FORM APPROVED  
OMB NO. 1004-0137  
Expires: January 31, 2018**SUNDRY NOTICES AND REPORTS ON WELLS**  
*Do not use this form for proposals to drill or to re-enter an abandoned well. Use form 3160-3 (APD) for such proposals.*5. Lease Serial No.  
NMNM18626

☒ Oil Well ☐ Gas Well ☐ Other8. Well Name and No.  
GINGER FEDERAL 1

RKI EXPLORATION & PRODUCTION RESPECTFULLY REQUESTS TO P&A THE ABOVE MENTIONED WELL.  
THE ATTACHED WBD AND PROCESS ATTACHED.

## Ginger Federal #1 Plug and Abandon Procedure

Ginger Fed #1  
Current WB

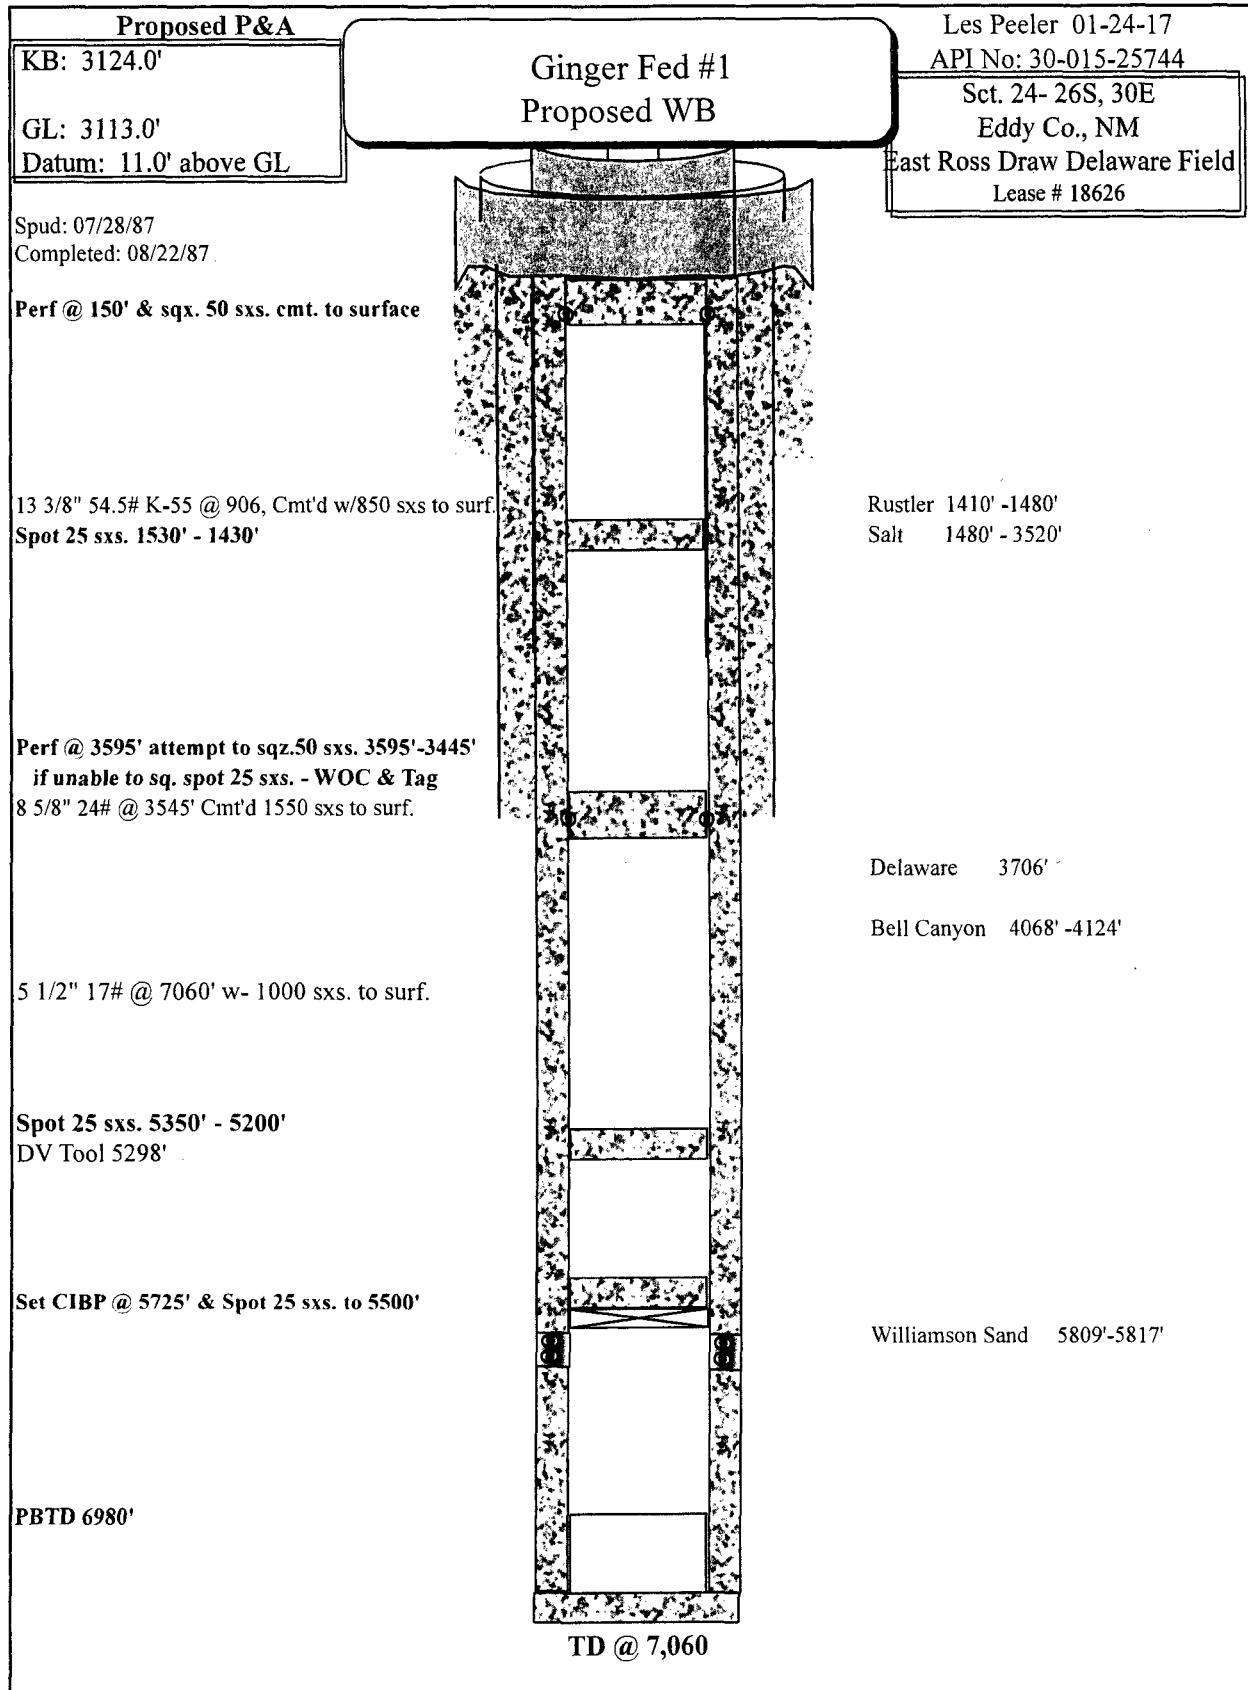
\*\* BLM REVISED \*\* BLM REVISED \*\* BLM REVISED \*\* BLM REVISED \*\* BLM REVISED \*\*

- 11) WOC & Tag @ 3,445'.
- 12) POOH to 1,530' & spot 25 sxs. 1,530' - 1,430'. *Set @ 1,530' sqz. cmt. to 1,300' woc*
- 13) POOH & LD Tbg.
- 14) RU WL & Perforate 4 holes @ 150'. RD MO wireline.
